A d d e n d u m

Iowa Department of Transportation
Office of Contracts

B.O.	Proposal ID	Proposal Work Type	County	Project Number	Addendum
011	57-1001-105	BRIDGE NEW - PPCB	LINN	NHSX-100-1(93)--3H-57 NHSX-100-1(94)--3H-57 NHSX-100-1(95)--3H-57 NHSX-100-1(96)--3H-57 NHSX-100-1(97)--3H-57 NHSX-100-1(98)--3H-57 NHSX-100-1(104)--3H-57 NHSX-100-1(105)--3H-57 NHSX-100-1(108)--3H-57	17MAY011.A03

Make the following changes to the NHSX-100-1(95)--3H-57 plans:

FILE NO.	ENGLISH	DESIGN TEAM	Iowa DOT/CH2MHILL	LINN COUNTY	PROJECT NUMBER	NHSX-100-1(105)--3H-57	SHEET NUMBER	Q.5
----------	---------	-------------	-------------------	-------------	----------------	------------------------	--------------	-----

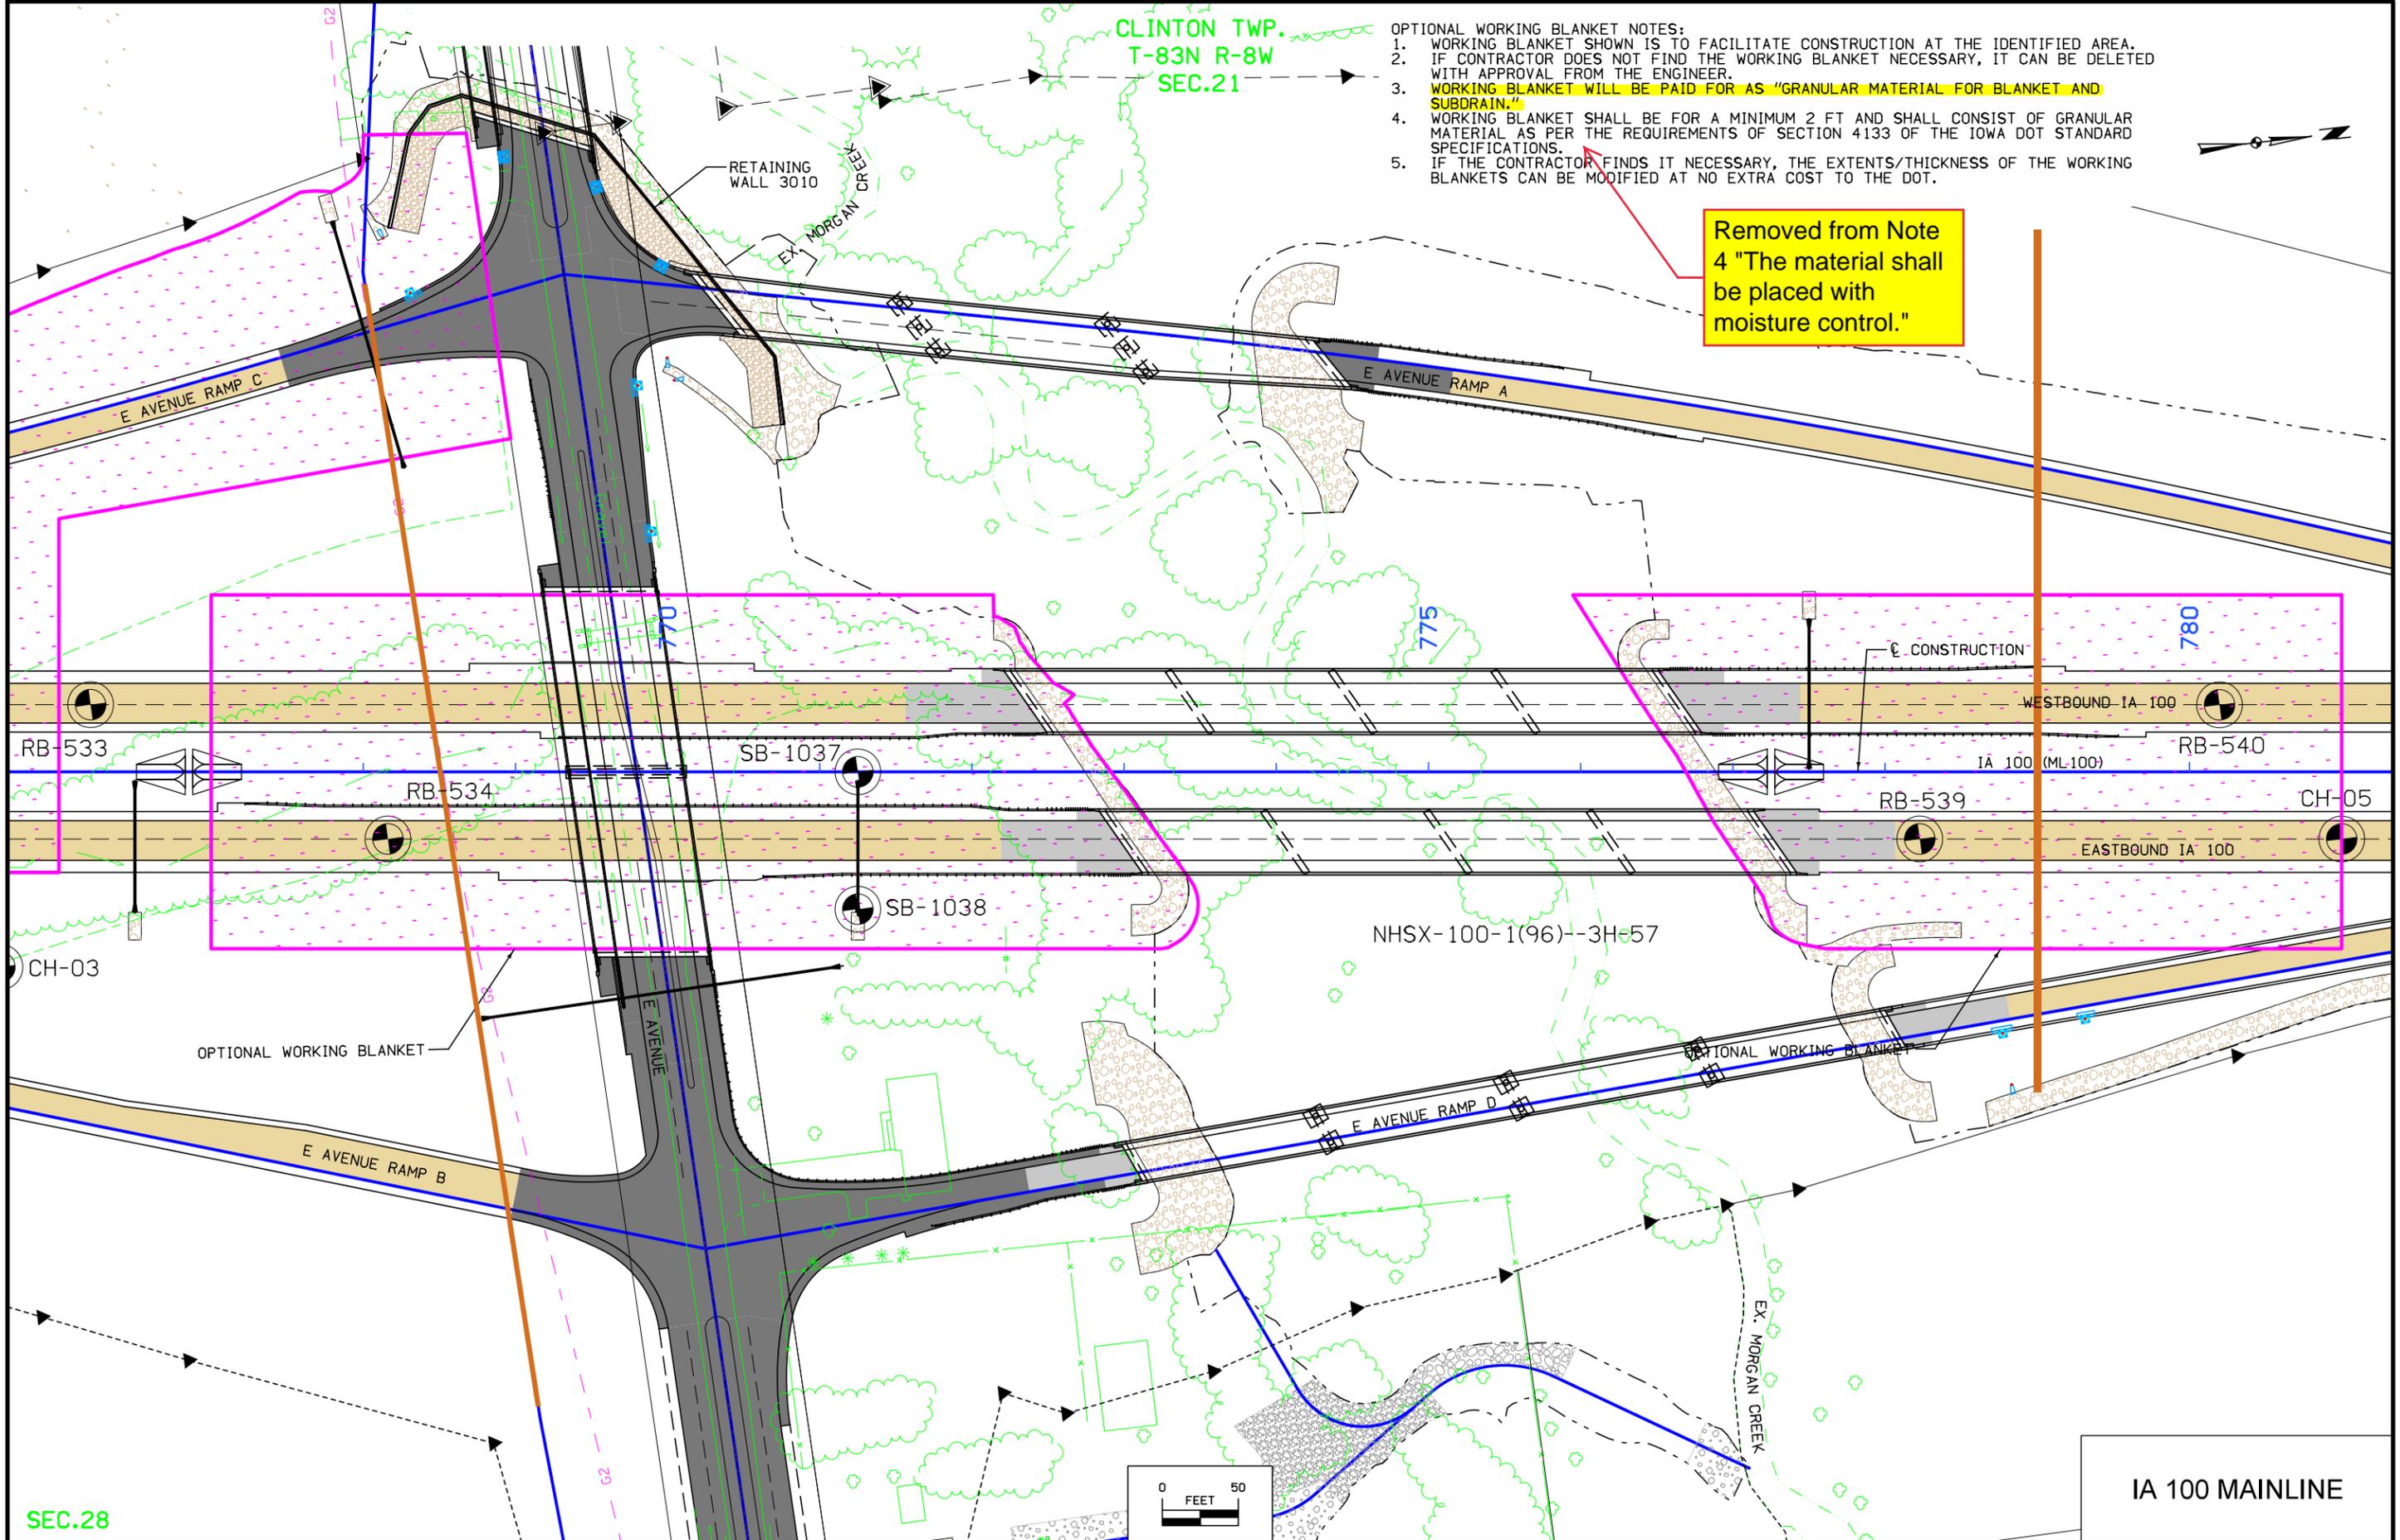
Removed from Note 4 "The material shall be placed with moisture control."

FILE NO.	ENGLISH	DESIGN TEAM	Iowa DOT/CH2MHILL	LINN COUNTY	PROJECT NUMBER	NHSX-100-1(105)--3H-57	SHEET NUMBER	Q.8
----------	---------	-------------	-------------------	-------------	----------------	------------------------	--------------	-----

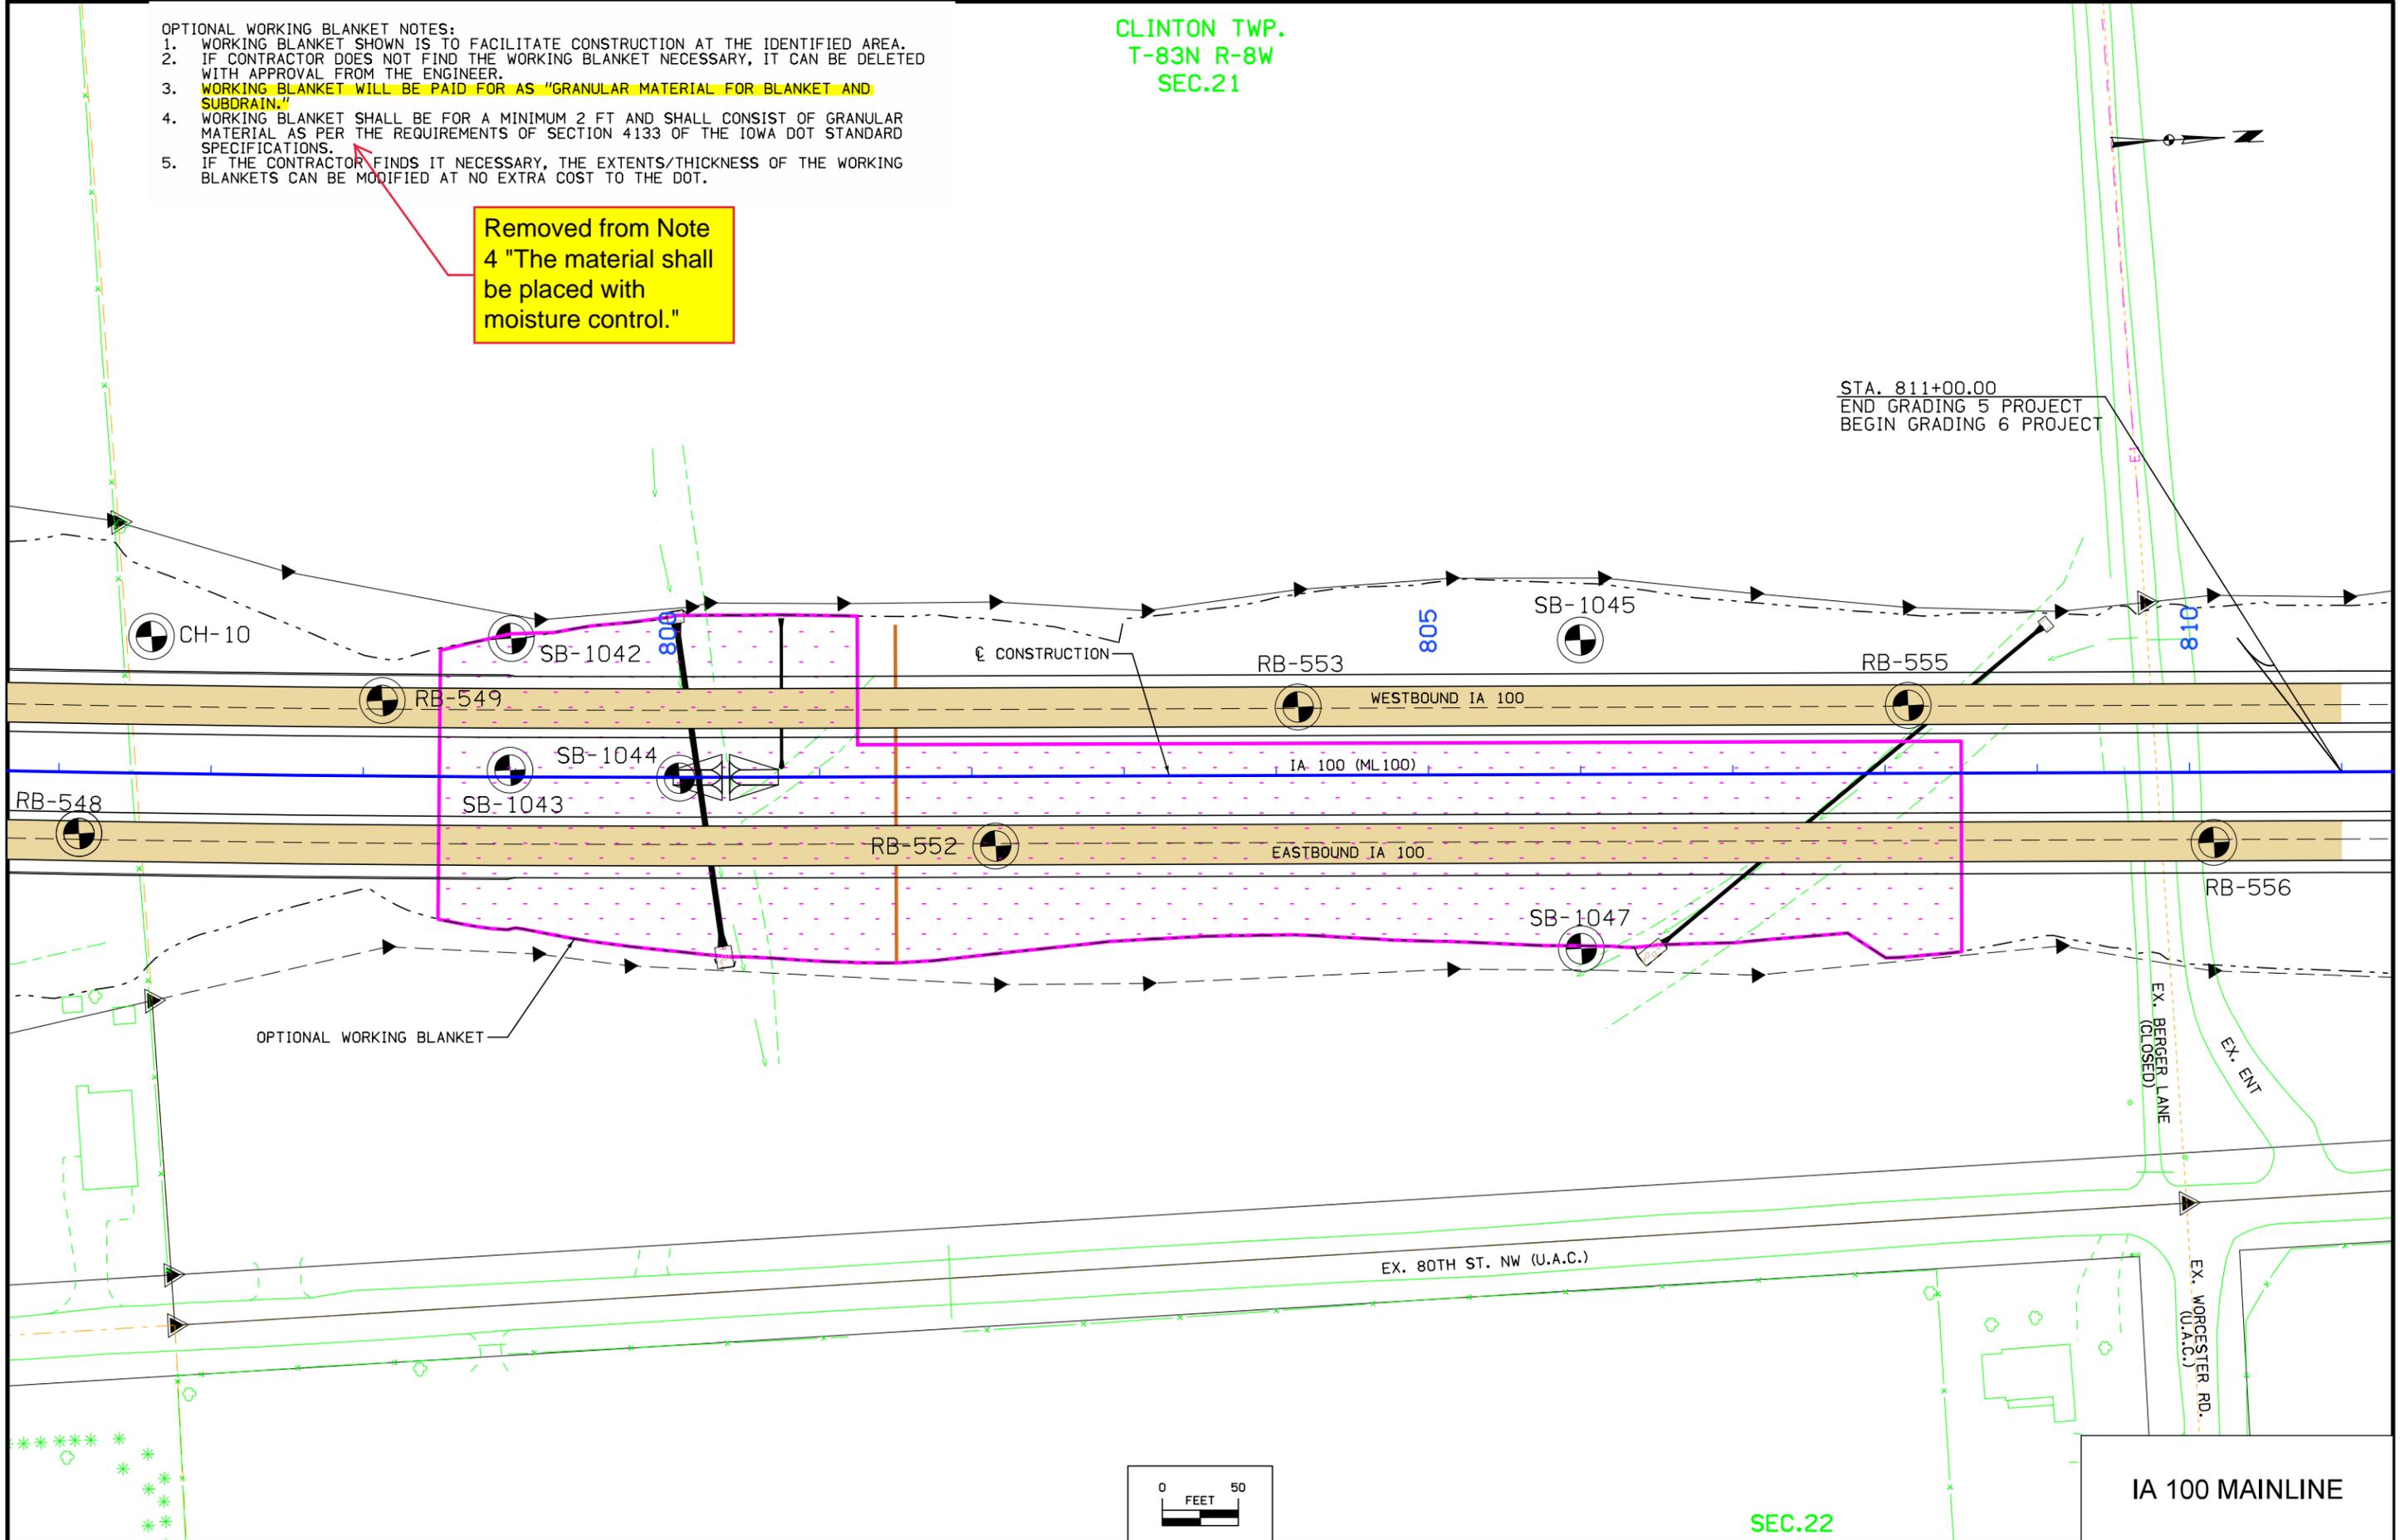
Removed from Note 4 "The material shall be placed with moisture control."

FILE NO.	ENGLISH	DESIGN TEAM	Iowa DOT/CH2MHILL	LINN COUNTY	PROJECT NUMBER	NHSX-100-1(105)--3H-57	SHEET NUMBER	Q.14
----------	---------	-------------	-------------------	-------------	----------------	------------------------	--------------	------

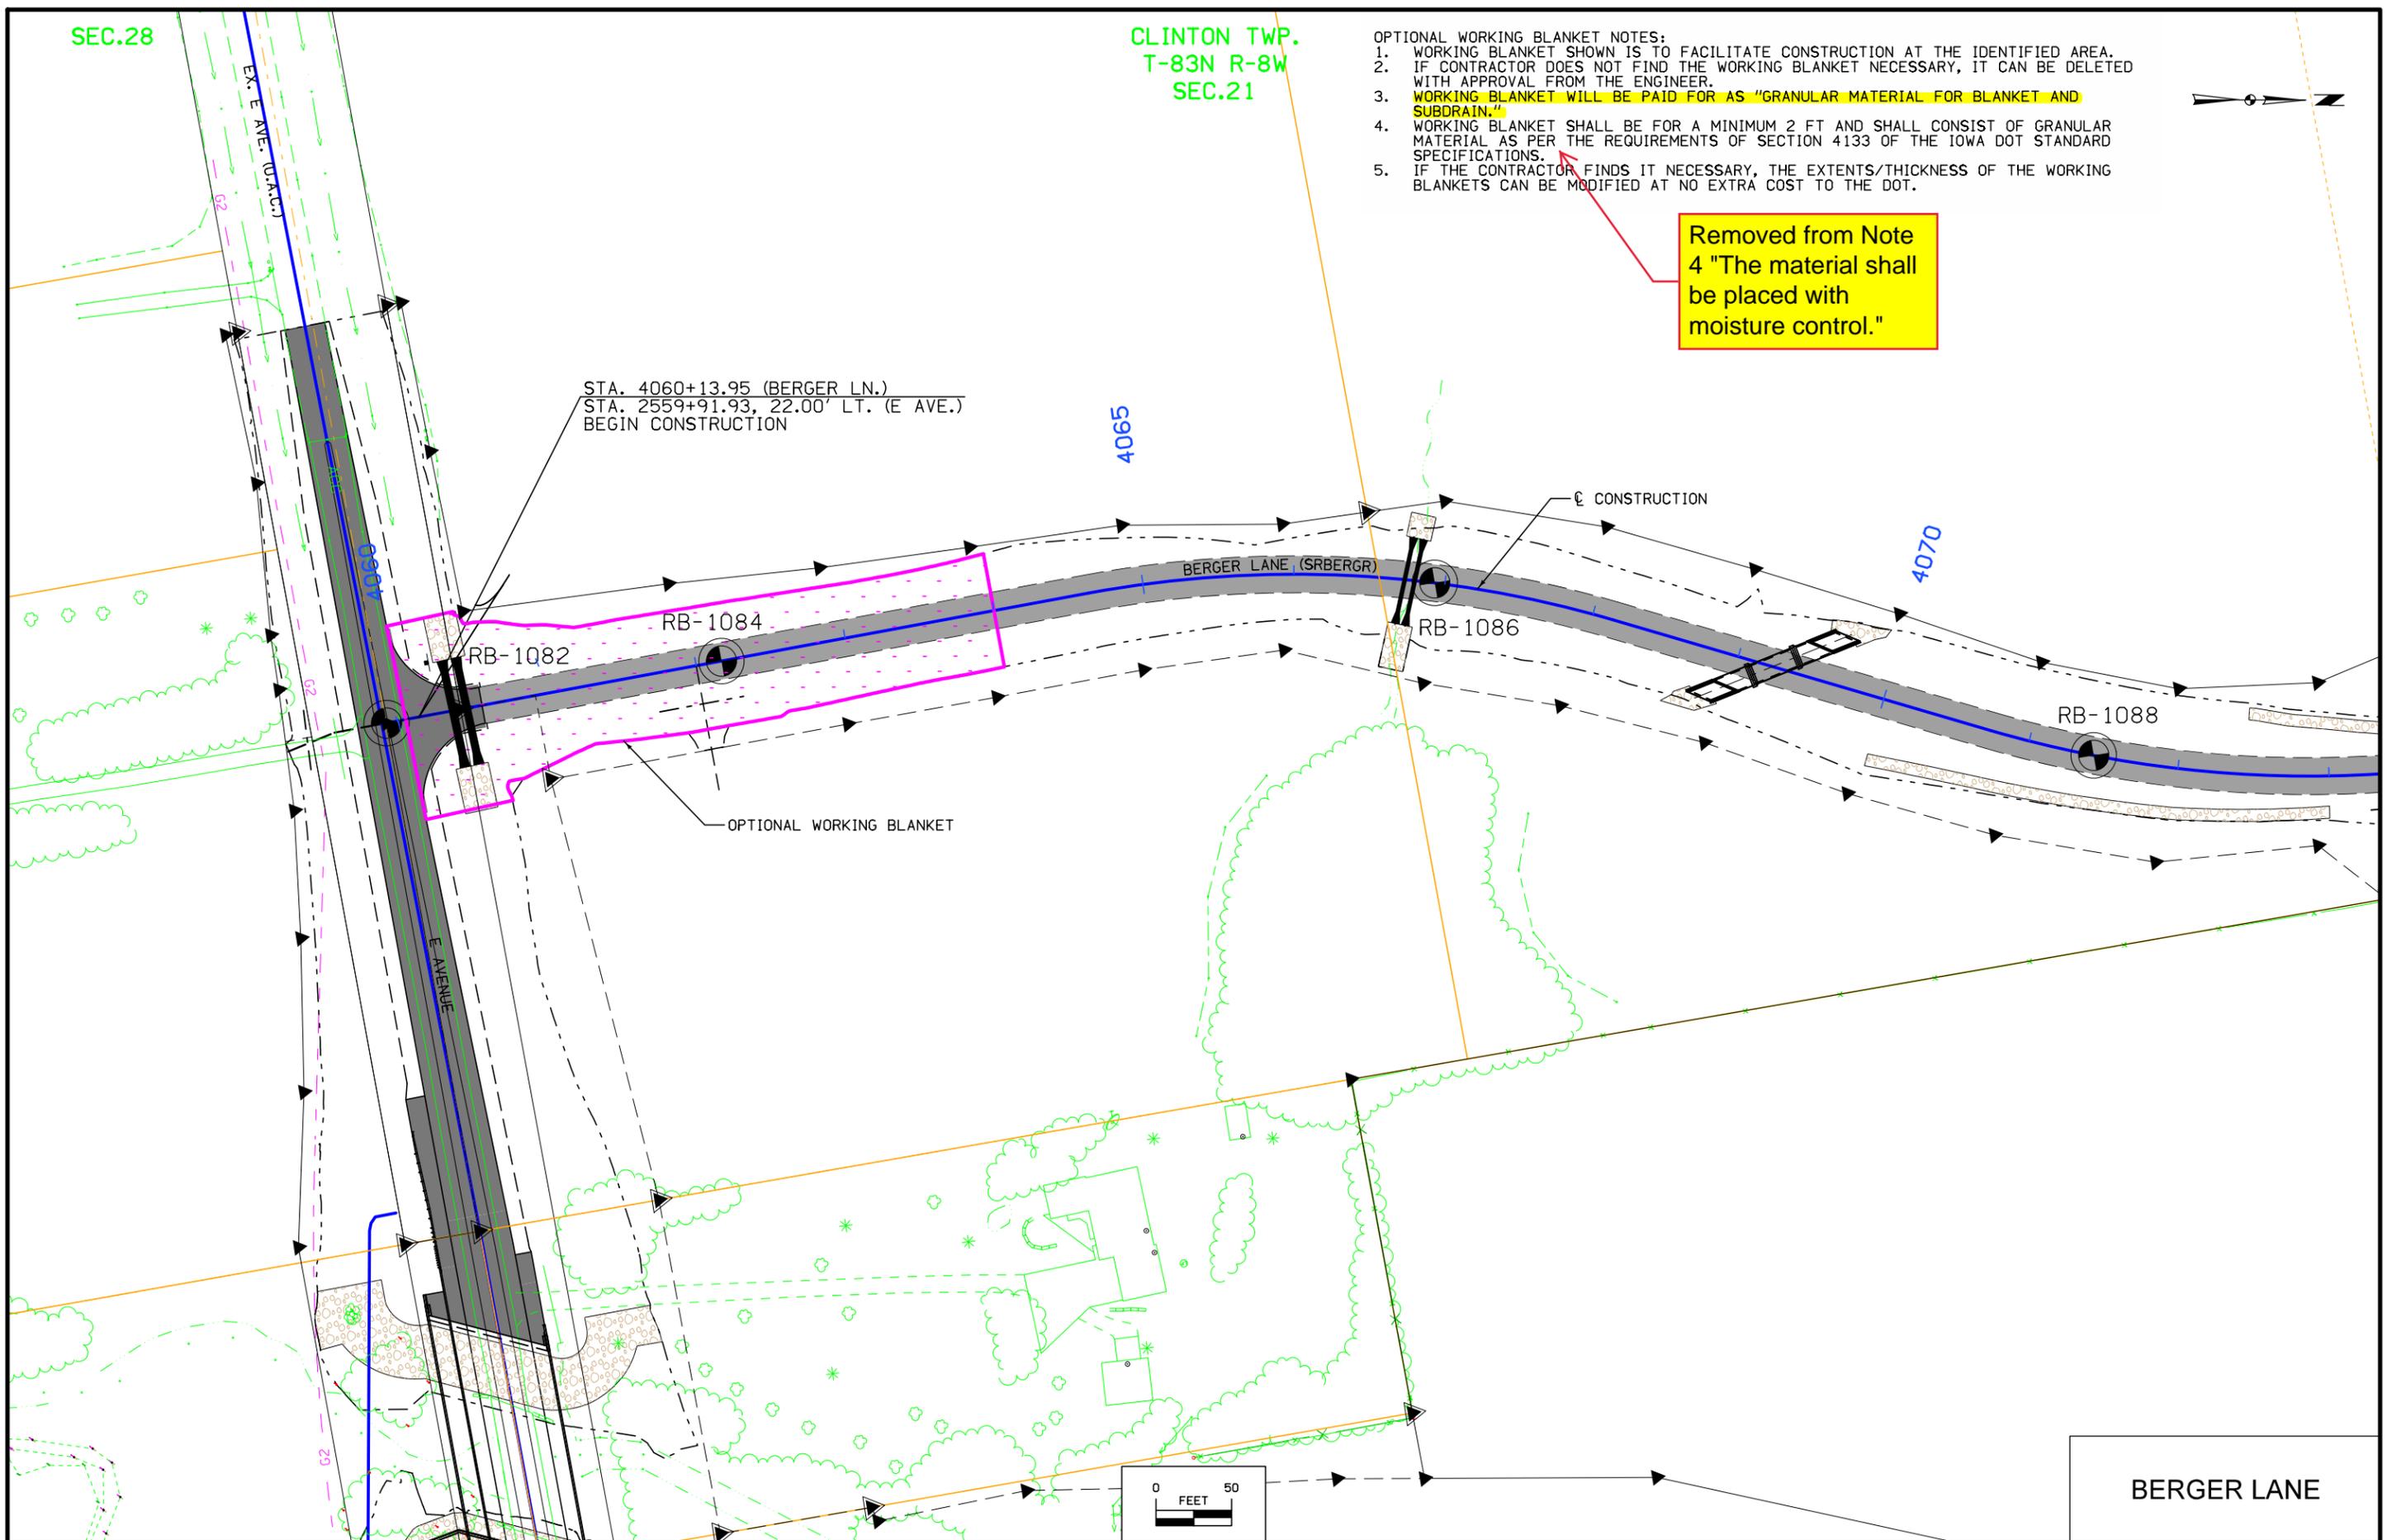
Removed from Note 4 "The material shall be placed with moisture control."
